SAFETY RECALL

2015~2020 MODEL XC155 (SMAX) SCOOTERS

FACTORY MODIFICATION CAMPAIGN - Primary Sheave Nut

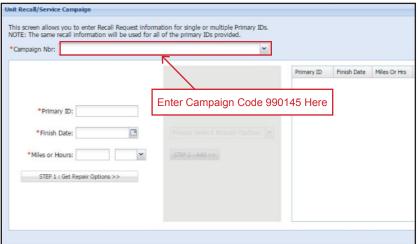
New and old parts can be identified by their appearance:

NUT

Old Part	New Part		
No flange	With flange		
Black color	Silver color

WASHER

Old Part	New Part		
Inner diameter: 12.5mm	Inner diameter: 12mm		
Outer diameter: 28mm	Outer diameter: 27 mm		
Thickness: 3 mm	Thickness: 2.3 mm		
Black color	Silver color

Order the XC155 Primary Sheave Nut kit.

PART NUMBER	DESCRIPTION	QTY	Application	DEALER COST
90891-10317-00	XC155 Primary Sheave Nut Kit Contains: Nut (90179-12019-00), Qty. 1 Washer (90201-12837-00), Qty. 1		XC155 (SMAX)	\$0.44
